Responses to Comments
Public Review of Merrimack Station
NPDES Permit No. NH0001465

U.S. Environmental Protection Agency
5 Post Office Square
Boston, Massachusetts 02109

Comment VIII.2.5	AR-1231, PSNH, p. 20

of Figure II.1. Mean daily (24-hour average) temperature (deg C) at Stations S0 (discharge), S4 (downstream), and N10 (ambient) from June 21 through September 30, 2004 compared to the yellow perch avoidance temperature (28.3°C). effort (CPUE) 22.00

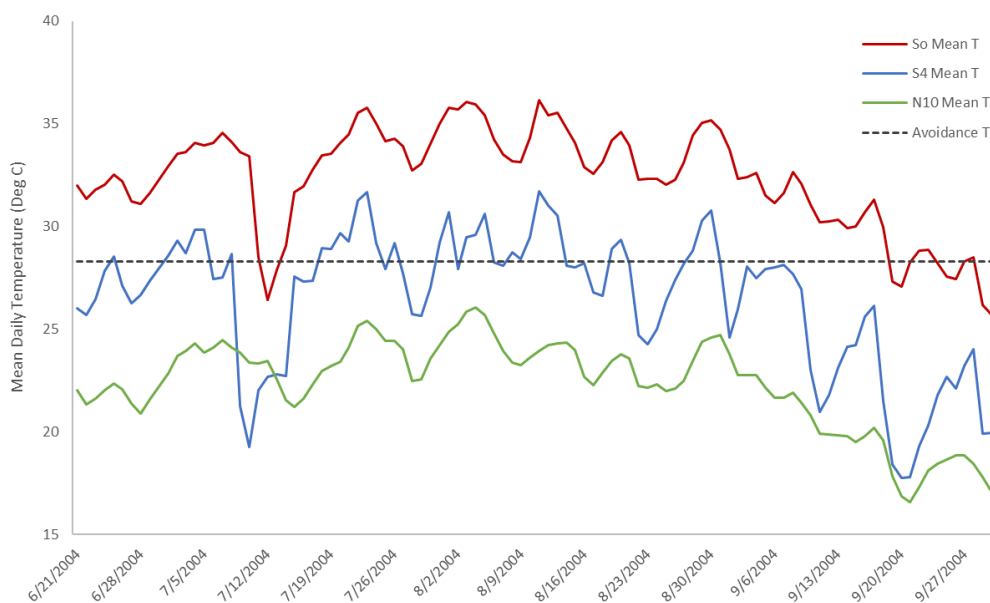
PSNH comments that EPA’s misinterpretation of Normandeau’s 2007 Thermal Model Report is a cornerstone of the Agency’s entire § 316(a) analysis and, as a result, the assertions and/or conclusions of the analysis are called into question. PSNH also provides a “representative sample of instances” from the 2011 Draft Determinations Document where erroneous conclusions were based on this misinterpretation of data.

EPA acknowledges that the temperature data at issue was an integral part of its analysis of the Facility’s thermal impacts in the 2011 Determinations Document and, therefore, a key factor in its proposed decision to reject PSNH’s requested variance under CWA § 316(a). (As PSNH’s consultants have acknowledged, though it is not mentioned in the above comment, EPA’s misinterpretation of the data resulted from the misleading or unclear way in which it was presented by the Facility.) EPA’s misinterpretation of temperature data (due to a lack of clarity in presentation) does not, however, necessarily support either that PSNH’s proposed § 316(a) variance should be granted or that the BIP will be protected. Instead, it supports a re-examination of the in-stream temperature data and the potential of the Facility’s thermal discharge to impact

the biological community of Hooksett Pool for the Final Permit. Consistent with that, in the comment above, PSNH lists examples where the maximum temperature led EPA to conclude that conditions in the Merrimack River are unsuitable for various life stages and species and suggests that, as a result of these errors, the temperature data and conclusions from the 2011 Draft Determinations Document must be revisited.

Figure II.2. Mean and maximum daily (24-hour average) temperature (deg C) at Stations S0 (discharge) and S4 (downstream) from August 10 through September 30, 2010 compared to the juvenile alewife avoidance temperature (28.9°C).

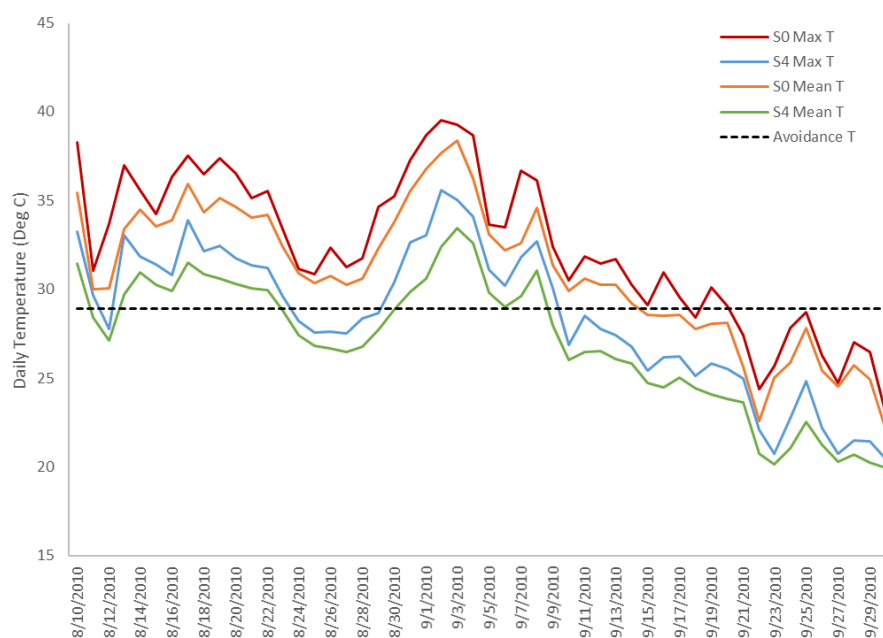
Based on the 2016 averaged data summary, LWB states that the average maximum temperature only exceeded 28.9°C on 14 days between July 16 and August 10, which is before juvenile alewife would be migrating. *See* AR-1300 p. 35, AR-1299. LWB and PSNH conclude that temperatures will be protective during the period in which alewives would be migrating past Merrimack Station. *See id.* EPA reviewed *daily* temperature data over the period from 2004 through 2018. The maximum daily temperature at Station S0 and S4 frequently exceeds 28.9°C after August 10 through early September, including as late as September 22 (at Station S4) and September 28 (at Station S0). Daily data from 2010 demonstrate that the mean daily temperature at S4 during that year was above 28.9°C from August 13 through August 22 and again from August 31 through September 9, and that the maximum daily temperature exceeded 28.9°C for nearly the entire period from August 10 through September 9 (Figure II.2, below). The daily data demonstrates that, in contrast to the LWB's analysis and consistent with EPA's conclusion in the 2011 Draft Determinations Document, temperatures in the river are above the protective temperature during the period when outmigrating juvenile alewife are present.

At the same time, EPA acknowledges that juvenile alewives could potentially avoid higher temperatures if the plume were sufficiently limited to allow areas of passage. The 2016 data demonstrate that the average daily temperature at Station S0 is less than the avoidance temperature of 28.9°C (84°F) on each day beginning on September 5, which indicates that river temperatures at S0 appear to be suitable for juvenile alewives by the end of the first week of September. When operating as a baseload plant, such as in 2010, the sustained, elevated temperatures could potentially exclude juvenile alewife from habitat downstream of the Merrimack Station for sustained periods, including when juveniles are outmigrating and must

Figure II.5. Mean and maximum daily (24-hour average) temperature (deg C) at Stations S0 (discharge) and S4 (downstream) from June 16 through September 10, 2007 compared to the juvenile and adult perch avoidance temperature (28.3°C).

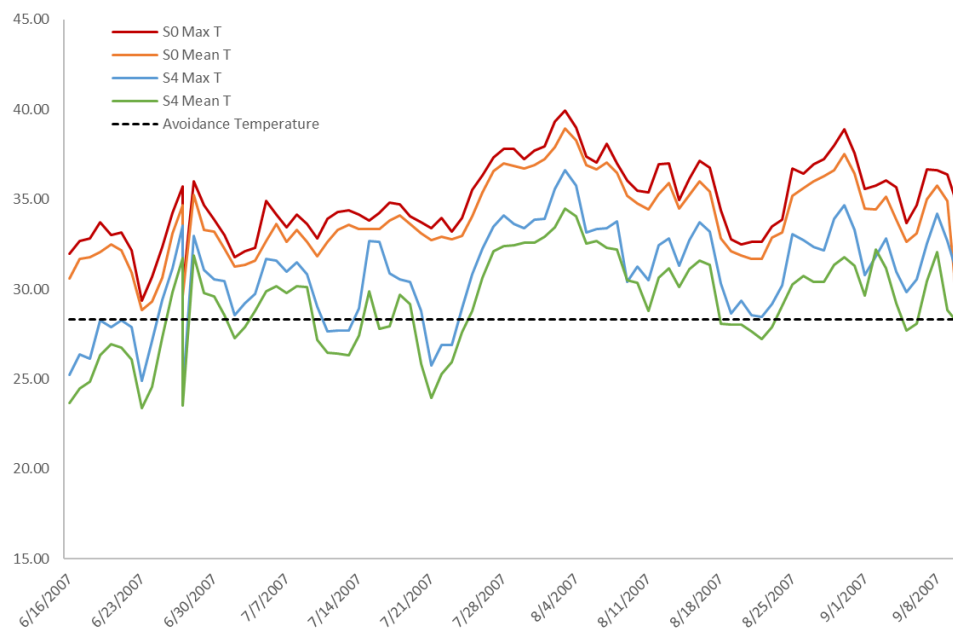
In the 2011 Draft Determinations Document, EPA concluded that temperatures at Station S4 reached or exceeded the avoidance temperature for yellow perch juvenile and adults (28.3°C) every day from June 15 to September 10. *See AR-618 p. 106.* Correctly interpreted, the maximum temperature from June 15 to September 10 was reached at Station S0 in at least one year out of this 21-year data set but not necessarily in the same or sequential years. LWB comments that, based on the average daily temperature data over the period from 2002 through 2015 (received in 2016), the 14-year average mean daily temperature at Station S4 did not exceed 28.3°C (83°F) on any calendar day during this period and the average daily maximum temperature reached or exceeded 28.3°C on 22 calendar days between July 16 and August 10. LWB also comments that juvenile and adult yellow perch would avoid the plume during the hottest part of the day when the S4 temperature exceeds the avoidance temperature. *See also AR-872 p. 107-8.* EPA notes that there are only 26 dates between July 16 and August 10, so the data shows the maximum average daily S4 temperature over the period 2002 through 2015 exceeded 28.3°C nearly all of the time between July 16 and August 10. EPA's review of daily temperature data from 2004 through 2011 indicates that the mean and maximum S0 and S4 temperatures steadily exceed 28.3°C between June 15 and September 10 in most years under baseload conditions, consistent with the analysis in the 2011 Draft Determinations Document. As an example, Figure II.5 illustrates persistent temperatures at the discharge and downstream that exceed the avoidance temperature for juvenile and adult yellow perch for the entire summer period. Even if adults and juveniles can avoid the plume by staying, as LWB suggests, in the cooler water upstream of the discharge, the thermal plume from Merrimack Station plainly caused a portion of Hooksett Pool to be unsuitable for yellow perch for the entire summer in multiple years.

However, the potential impacts of the thermal plume on juvenile and adult yellow perch have changed substantially since 2012 when Merrimack Station transitioned to a peaking plant. Figure II.6 illustrates that, under current operating conditions (in 2016, which is representative of above average operating capacity compared to recent summers), the mean and maximum daily temperature at Station S0 only occasionally reached or exceeded avoidance temperatures for yellow perch and exceedances that did occur were limited to a few days. The mean daily temperature at Station S4 did not exceed avoidance temperatures for yellow perch and the maximum temperature rarely exceeded the avoidance temperature. The data suggests that, under current operations, juvenile and adult yellow perch are likely to avoid the plume and will not be excluded from potentially suitable habitat for extended periods of time. EPA has also determined, in response to this and other comments received, that acute mortality is not likely to occur as a result of exposure to the thermal plume first because under current operations it is uncommon for river temperatures to exceed the acutely lethal temperature between Stations S0 and S4 and second, because yellow perch juveniles are mobile and can avoid the relatively rare extreme temperature events that may occur for limited periods of time in the segment of the river between Stations S0 and S4. *See Response to Comment II.3.4.7.* Finally, PSNH and LWB comment that protective temperatures for yellow perch maturation during the winter is “highly speculative.” EPA addresses comments on protective temperatures during the yellow perch maturation period in detail in *Response to Comment II.3.4.7.*

Figure II.7. Mean and maximum daily (24-hour average) temperature (deg C) at Stations S0 (discharge) and S4 (downstream) from June 4 through July 2, 2007 compared to the larval white sucker lethal temperature (31.7°C).

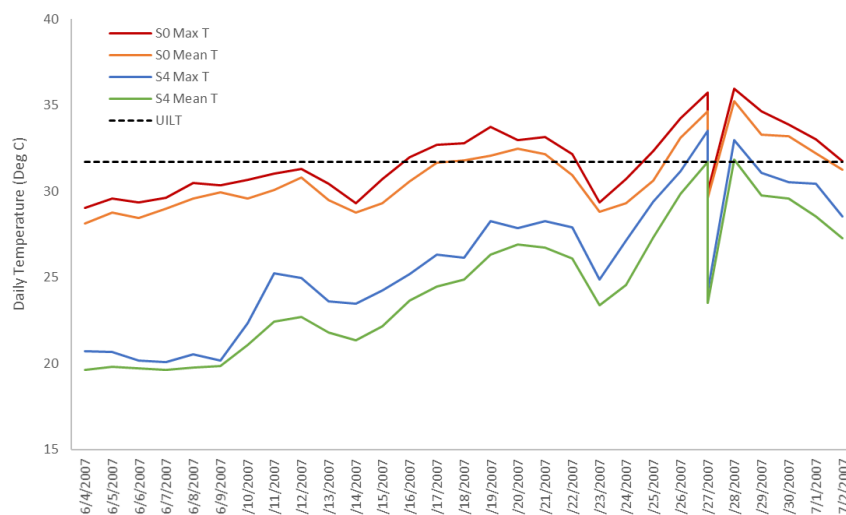
In the 2011 Draft Determinations Document, EPA concluded that maximum daily temperatures at Station S0 and S4 exceeded lethal temperatures for white sucker larvae (30°C - 31.7°C) when larvae are present in the Merrimack River. *See* AR-618 p. 112. Correctly understood, however, the 2007 Normandeau report data only showed that the maximum temperature from June 4 to July 2 reached potentially lethal temperatures on each day in at least one year out of the 21-year data set and did not necessarily reach that level on multiple days in the same year or in sequential years. According to LWB, the 2016 temperature data show that the average daily maximum temperature during all dates between June 4 and July 2 never exceeded the white sucker upper incipient lethal temperature at either station. *See* AR-1300 p. 36-7. Reviewing the daily temperature data for June 4 to July 2 for the years 2004 through 2018, however, demonstrates that the daily maximum and mean temperature at S0 frequently exceeded 31.7°C in every year from 2004 to 2011 on multiple, consecutive days (except in 2006, when there was only one exceedance of 30°C). The mean daily temperature at Station S4 exceeded 31.7°C on only two dates (at the end of July in 2007) over the entire period, while the maximum daily S4 temperature exceeded 31.7°C in three of the years (on 2 consecutive days in 2004, 6 days in 2007, and 7 days in 2010). As an example, Figure II.7 presents the mean and maximum daily temperatures at S0 and S4 for this time period in the year 2007. Re-examining the observed daily temperature data supports the 2011 Draft Determinations Document's conclusion that white sucker larvae could be exposed to potentially lethal temperatures in the thermal plume during the period when they are likely to be present, including, in some years, in early to mid-June when surface-feeding yolk-sac larvae are expected to be present. *See* AR-618 p. 113-14. At the same time, temperatures fell, on average, 4°C to 10°C between Stations S0 and S4, and temperatures were typically below the UILT by Station S4, suggesting that the duration of exposure to

potentially lethal temperatures would be limited in most cases. In addition, temperatures have not exceeded the UILT at Station S4 since 2012, when operations transitioned to a peaking-like plant, with a single exception (maximum daily temperature on 7/2/2018). As a result, EPA concludes that the Final Permit's limits, which include an acute mortality limit at Station S4, will ensure that conditions in the river are protective of white sucker larvae and will not result in acute mortality. *See Response to Comment II.3.4.7.*

Figure II.8. Mean and maximum daily (24-hour average) temperature (deg C) at Stations S0 (discharge) and S4 (downstream) from June 25 through September 1, 2007 compared to the avoidance temperature for juvenile and adult white sucker (29.9°C).

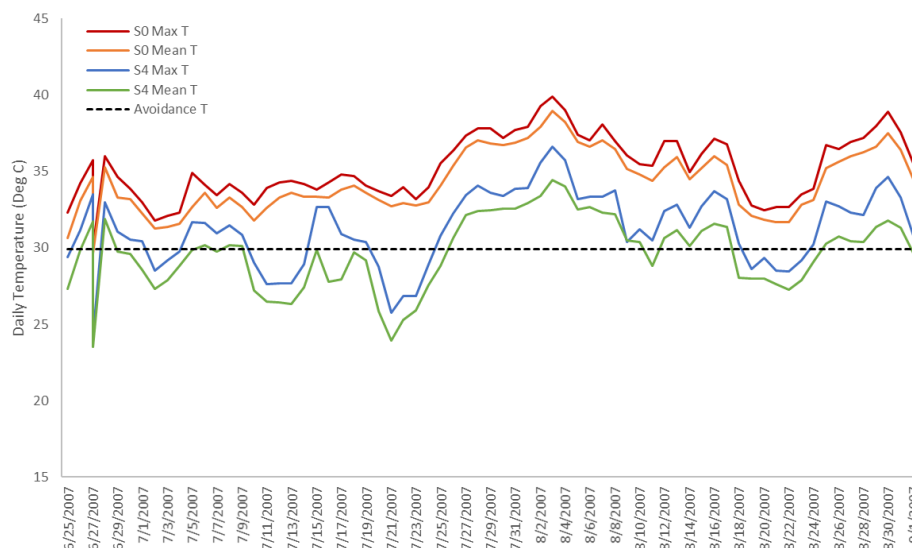
In the 2011 Draft Determinations Document, EPA concluded that maximum daily temperatures at Station S4 routinely exceeded avoidance temperatures for white sucker juveniles and adults (29.9°C) every day from June 25 to September 1, while average maximum temperatures at Station N10 remained below 29.9°C. *See AR-618 p. 112.* Correctly understood, the 2007 Normandeau report data only showed that the maximum temperature from June 25 to September 1 exceeded avoidance temperatures on each of those days in at least one year out of the 21-year data set, but did not necessarily do so on multiple days in the same year or in sequential years. According to LWB, the 2016 report presenting the average of the multi-year temperature data shows that the average daily maximum temperature at Station S4 reached 29.4°C (85°F) on only 3 dates during July, and never exceeded the avoidance temperature (29.9°C). *See AR-1300 p. 37. See also AR-872 p. 112.* Yet, reviewing the actual, observed daily temperatures demonstrates that the daily maximum and mean temperature at S4 routinely exceeded 29.9°C between June 25 to September 1 in 2004, 2005, 2007, 2010, and 2011, albeit not every day. Figure II.8, from 2007, supports the 2011 Draft Determinations Document's conclusion that daily maximum and, in some cases, mean S4 temperatures reach avoidance temperatures for juvenile and adult white sucker for large portions of the summer.

LWB points out that white sucker adults and juveniles can avoid the thermal plume, for instance, by staying upstream of the discharge where ambient temperatures are in the preferred range. According to LWB, “these fish may prefer cooler water upstream from the discharge than warmer water below the discharge, although other habitat characteristics besides temperature could explain this distribution.” AR-1300 p. 14. Electrofish sampling in 2010 and 2011 (when the Facility was operating at a relatively high capacity) supports this assertion as catch-per-unit-effort (CPUE) for white sucker north of the discharge was more than four times higher than the CPUE at stations south of the discharge. *See* AR-871, p. 42 (where Group IIB2 is represented mainly by stations in northern Hooksett Pool and IIB1 is represented mainly by stations in southern Hooksett Pool). White sucker adults and juveniles can avoid the plume, but persistent, elevated temperatures downstream of the discharge could exclude these fish from this habitat for nearly the entire summer. Under current operating conditions (*i.e.*, operating like a peaking plant from 2012 through 2018), however, the maximum daily river temperature at Station S4 reached 29.9°C on several occasions but, with the exception of July and August 2012, the duration of the event was limited (5 days or less) and the mean daily S4 temperature did not exceed 29.9°C. The change in operations of the Station since 2012 has decreased the number and duration of events when the temperature at Station S4 reaches or exceeds the white sucker avoidance temperature, which suggests that the habitat downstream the discharge would typically be available to, and protective of, white sucker juveniles and adults. There was no difference in the CPUE for white sucker in the northern and southern sections of Hooksett Pool during electrofish sampling in 2012 and 2013, when the Facility ran 5-15 days in August and September. *See* AR-1551, p. 19.

Figure 1: Merrimack Quarterly Heat Input, 1995-Present²¹

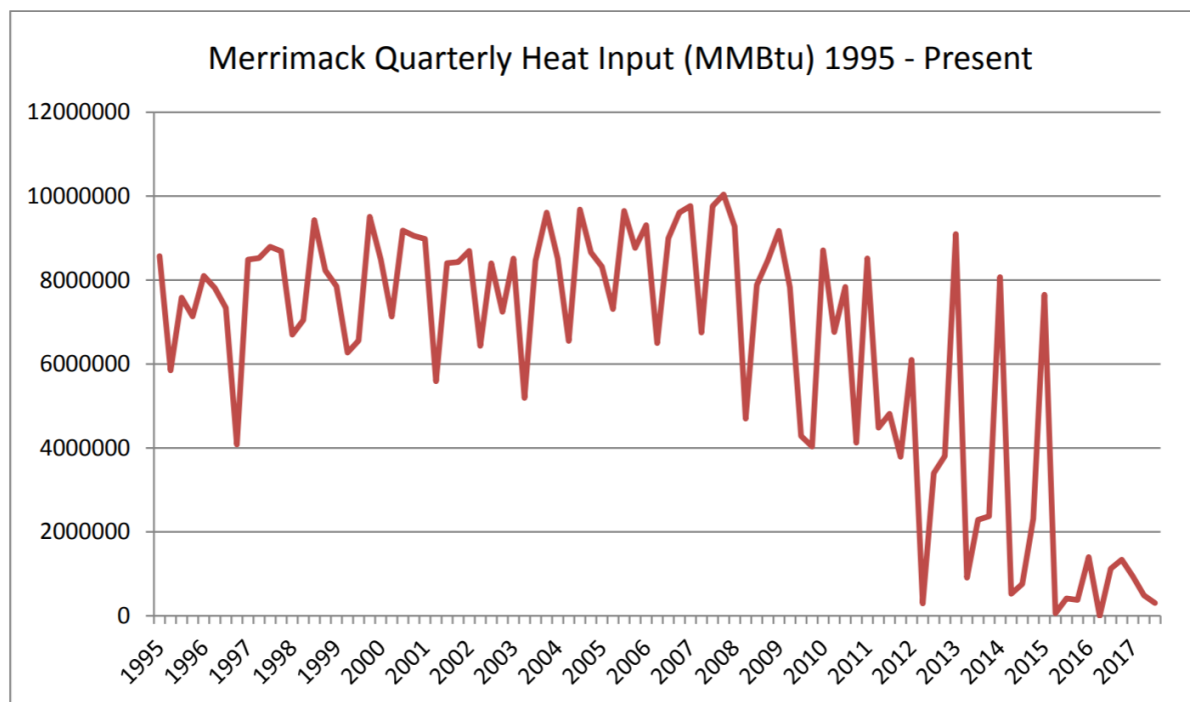
Second, as EPA implicitly recognizes, while Merrimack’s annual capacity factor may be lower in recent years than in years further back, it still operates quite heavily for short periods of time in the winter and in the summer. Setting limits based on annual output would improperly ignore Merrimack’s high level of operations, and concomitant environmental impacts, during those periods of time. This would be particularly troublesome given the seasonality of the thermal impacts described above, where it is precisely the thermal pollution Merrimack causes during the winter that provides a toehold for invasive species and threatens the balanced indigenous population of aquatic species in the Merrimack river.

Third, the unfortunate fact is that EPA is extremely slow in issuing NPDES permits for large facilities in New Hampshire, and for Merrimack in particular. These comments are submitted as part of the third round of comments solicited by EPA on this one permit, in a process that started over five years ago. Indeed, Merrimack has been operating under a permit that expired two decades ago, and was issued a quarter-century ago. Although Commenters certainly hope that EPA will finalize this permit soon, and will thereafter hew to the five-year permit review cycle mandated by Congress, the history of this permit and this plant raises the possibility that whatever permit EPA does finalize for Merrimack may govern the plant’s operation for many years to come. Just as Merrimack’s operation has changed considerably in the past, it is possible that it will vary considerably in the future.

As such, it would be both irresponsible and contrary to law for EPA to set NPDES permit limits for Merrimack based on an assumption that, because the facility currently operates at a relatively low capacity utilization, certain wastestreams and pollution levels are unlikely to be relatively high in the future and therefore need not be limited.

Figure II.9. Mean and maximum daily (24-hour average) temperature (deg C) at Stations S0 (discharge) and S4 (downstream) from October 1 through October 31, 2015 compared to the adult yellow perch avoidance temperature (28.9°C).

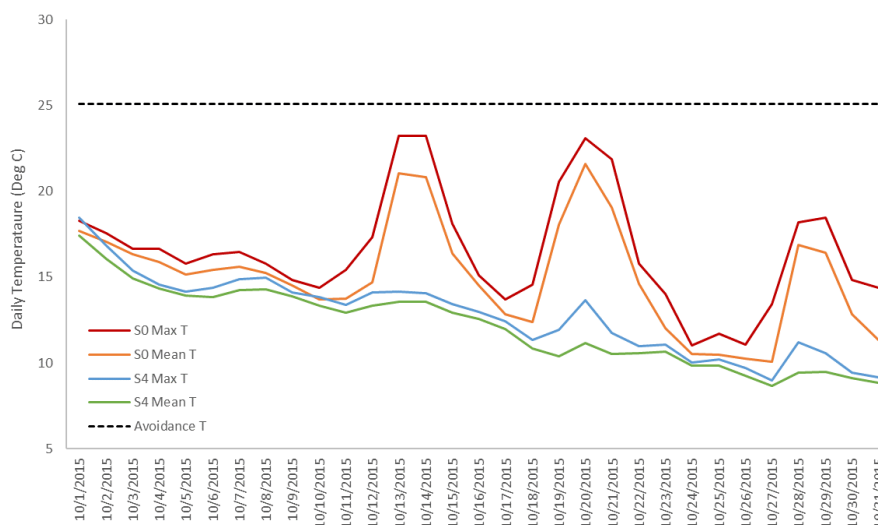
Yellow perch juveniles are the most thermally tolerant phase of the life cycle of yellow perch. McCormick (1976) found maximum growth rates at 28°C. Hokanson (1977) identifies 24.7°C as the physiological optimum for yellow perch based on studies using juveniles. EPA calculated an upper limiting temperature (28.4°C) using the method identified in the Gold Book. This upper limiting temperature is above the physiological optimum calculated in the 2011 Draft Determinations Document (26.4°C). EPA maintains that a weekly average limit of 28.4°C at Station S4 in October will be protective of yellow perch juveniles. Temperatures in the thermal plume are highest where the discharge canal meets the Merrimack River (Station S0) and decrease as the plume travels downstream. Under baseload operation during the month of October, the temperature decreased 3° to 10°C as the plume traveled from Station S0 to S4, which indicates that generally the plume will be quickly mixed when it joins the Merrimack River during October. River temperatures will continue to decrease downstream of Station S4 as the plume becomes fully mixed. Therefore, compliance with a weekly average temperature of 28.4°C at Station S4 ensures that the plume is at or better than the optimal range for yellow perch juveniles downstream of Station S4. Competitive interactions of yellow perch juveniles could be affected if the entire Hooksett Pool were at a temperature of 28.4°C because that is, as the comment points out, at the upper range for this species and might favor more thermally tolerant species. However, the thermal limits proposed in the 2011 Draft Determinations Document would ensure that, at most, only a small area of the river would be impacted by the plume and most of the Pool would be unaffected or at temperatures that are within the optimal range. Even water quality standards allow a limited area and volume of the river to be designated as a mixing zone within which water quality standards may be exceeded, but New Hampshire's water quality standards do not set specific instream temperature limits for the river.

Moreover, while EPA maintains that the proposed temperature would be protective of juvenile yellow perch, the effective temperature limit would be the most stringent water quality-based temperature limit proposed for the time period from October 1 through November 1, which would actually be 25.1°C (for adult yellow perch) and would also be sufficiently protective of juvenile perch. Finally, in recent years Merrimack Station has rarely operated in October (the highest average monthly capacity since 2012 was about 4% in 2015). Figure II.9 demonstrates the actual daily temperatures at Stations S0 and S4 in October 2015 which was the highest capacity year for the month of October since the Facility transitioned to operating like a peaking plant. Since 2012, the average rise in temperature at Station S4 as compared to Station N10 (ambient) was less than 0.5°C. Therefore, no problems are anticipated for yellow perch, or other species, during that time frame and EPA's limits for the Final Permit are sufficiently protective.

Figure 3-1. Trends in electrical generation by season at the Merrimack Station, 2007 - 2016.

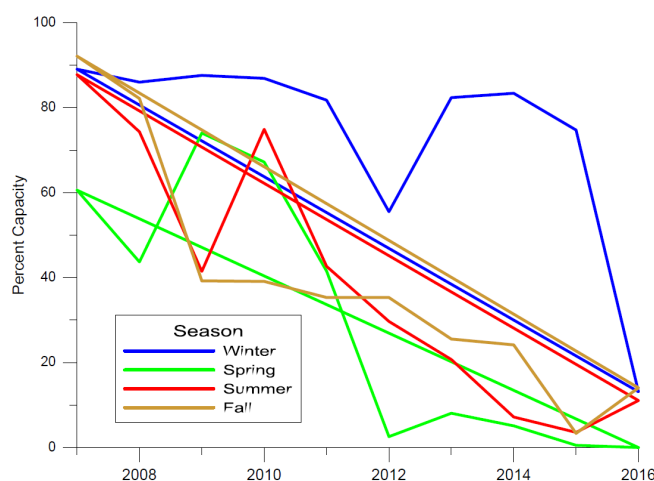
First, the potential thermal exposures should reflect likely operation of the Merrimack Station over the upcoming NPDES permit period (typically five years). As clearly demonstrated in ISO New England (2017), the Station no longer operates as a base-loaded facility as it had prior to

2010. Hence, temperature monitoring data collected prior to the draft NPDES permit (2011) does not reflect current conditions. The Merrimack Station operates principally as a peaking facility operating only when economic dispatch requires. A re-graphing of the generation data provided in ISO New England (2017) reveals a distinct seasonal pattern in operation (Figure 1). This graph clearly illustrates a substantial decline in the electrical generation at Merrimack since 2007 throughout the year except during winter. Hence, the magnitude and extent of thermal exposures to the aquatic community during most of the year are likely to be much lower than when Merrimack was operating as a baseload facility. During spring and summer, when biological productivity and potential for thermal stress is highest, Merrimack is typically operating at a capacity factor of less than 20 percent. That is only a small fraction of generating capacity of this facility prior to the 2011 draft NPDES permit. Only during winter, when natural gas availability constraints limit operation at other generating facilities is Merrimack called to run often. However, biological stresses from elevated temperatures at this time of the year should be minimal owing to low river water temperatures.

Figure - *Corbicula Fluminea* in the United States

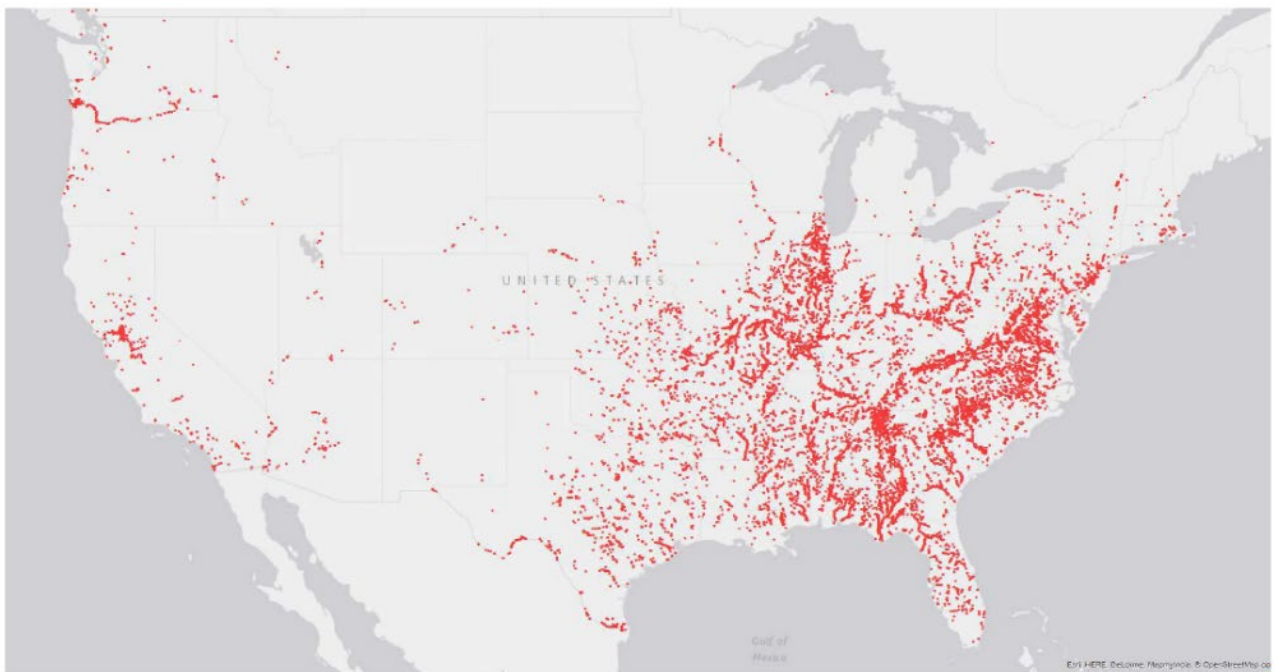
The Asian clam is ubiquitous, as the Statement notes,²⁸¹ and found throughout the United States near power plants and elsewhere. Asian clams are prolific up major waterways in the west (e.g., Columbia River, Sacramento Delta region), up the Mississippi and Ohio Rivers and their watersheds, and along the east coast in major harbors, rivers, and their various tributaries. The figure below shows the extent of the Asian clam's presence in the United States:
